RENESAS TECHNICAL UPDATE

Product Category	MPU & MCU	Document No.	TN-16C-A219A/E	Rev.	1.00
Title	Errata to R32C/161 Group Hardware Manual		Information Category	Technical Notification	
Applicable Product	R32C/161 Group	Lot No.	Reference Document	R32C/161 Group Hardware Manual Rev. 1.02 (REJ09B0517-0102)

This document describes corrections to the R32C/161 Group Hardware Manual, Rev. 1.02.
The corrections are indicated in red in the list below.

Figure 26.2 Addresses for ID Code Stored

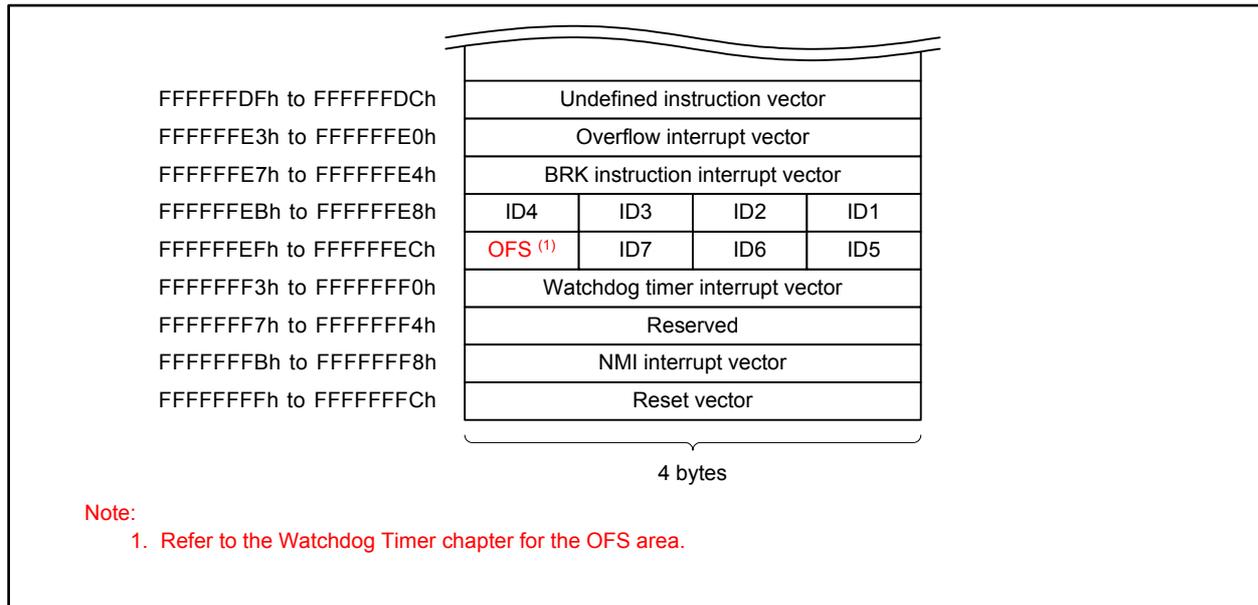
•Page 494 of 586, Figure 26.2 is corrected as follows:

Figure 26.12 Read Timing

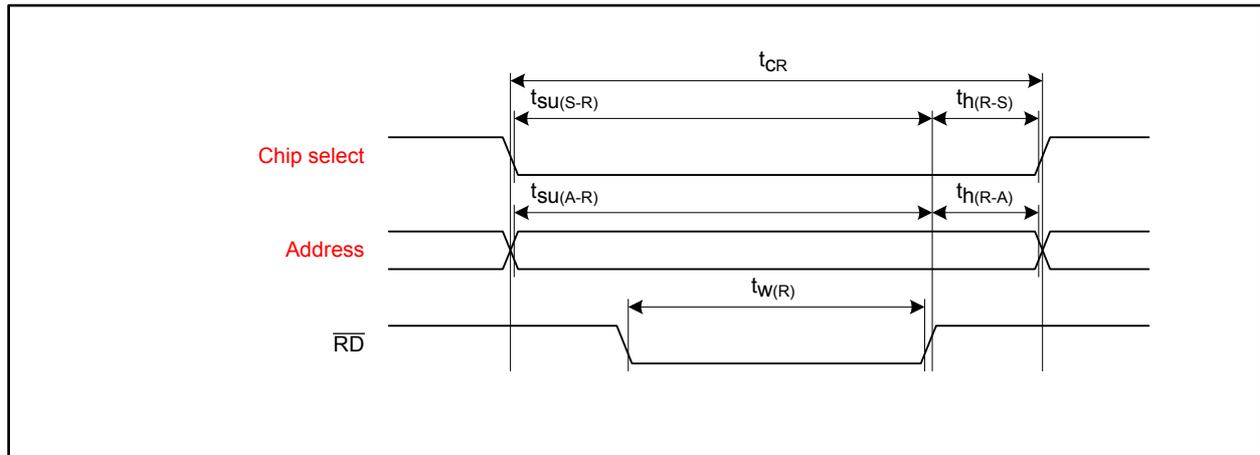
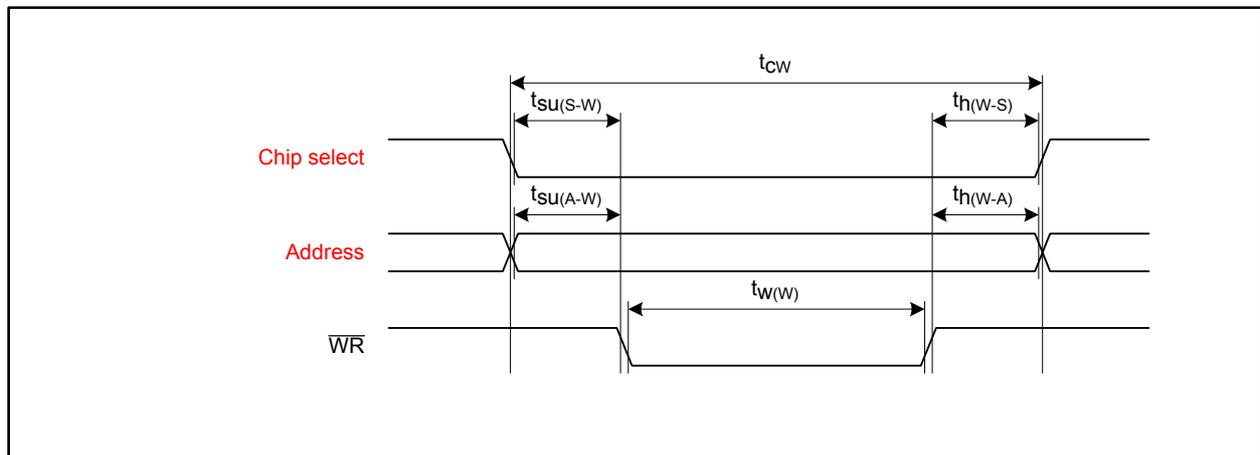
- Pages 502 and 504 of 586, descriptions in Figures 26.12 and 26.13 are corrected as follows:

Figure 28.5 Flash Memory CPU Rewrite Mode Timing

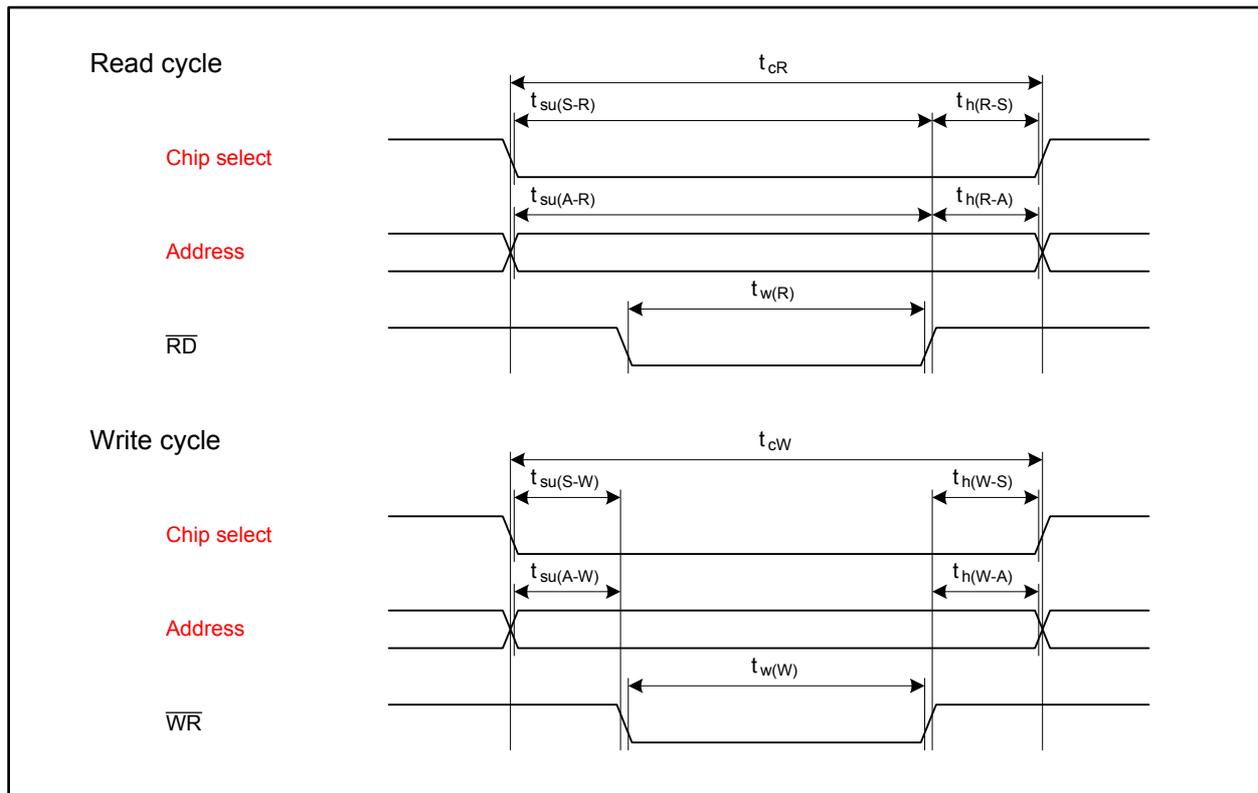
- Page 541 of 586, descriptions in Figure 28.5 are corrected as follows:
